## Architect's Field Report

16 February 2022

15094 Community Bank Headquarters / Report Number 034

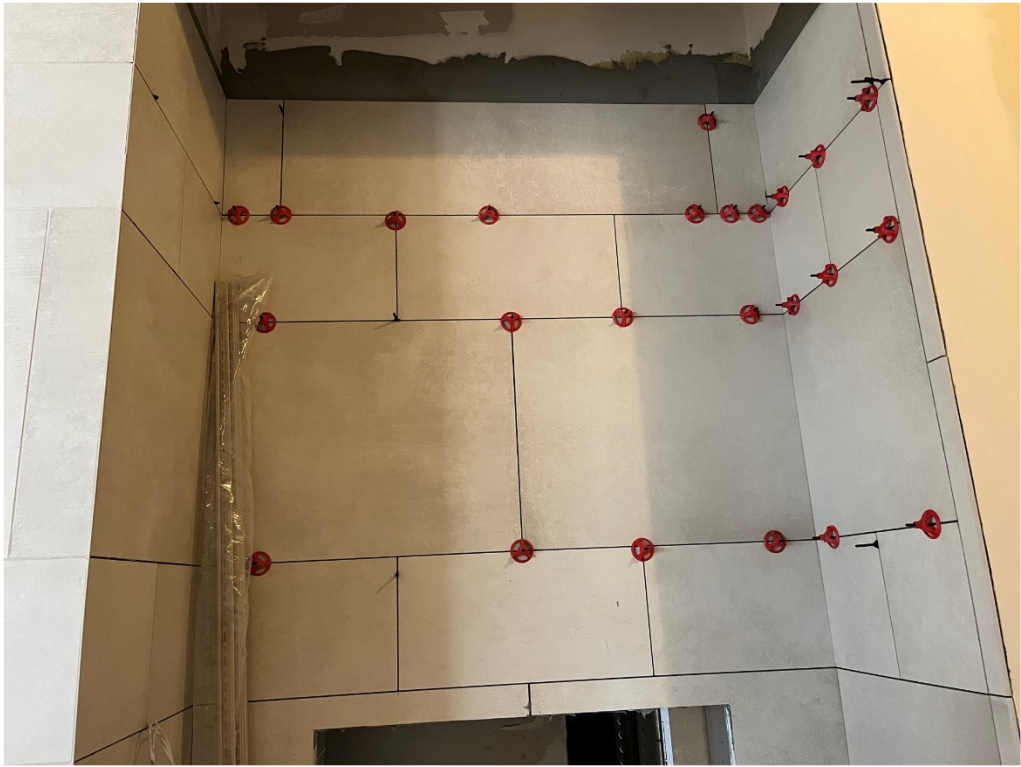
Figure 5 – Is this nook to receive tile; per an email sent on the 10<sup>th</sup> of January, I did not think so, but perhaps something has changed?

**#282: Remove and reinstall sealant at wall caps and storefront connection**

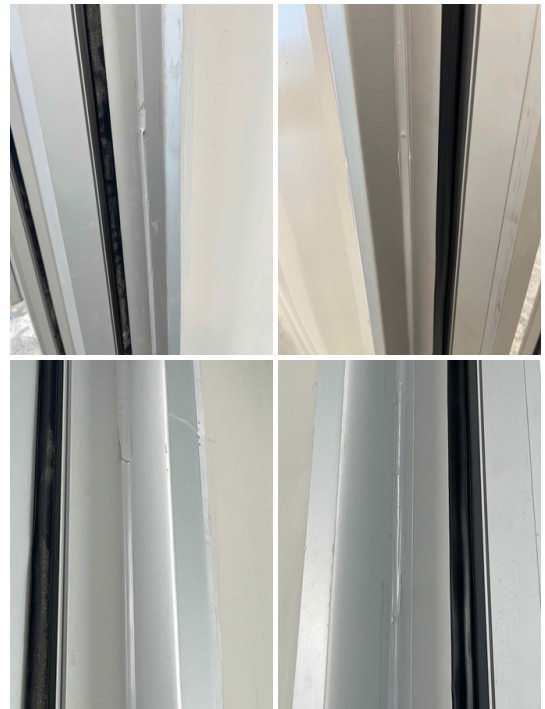
Assignee: **Rex Robinson (American Glass Company, Inc.)** Description: **Remove and reinstall sealant at wall caps and storefront connection**
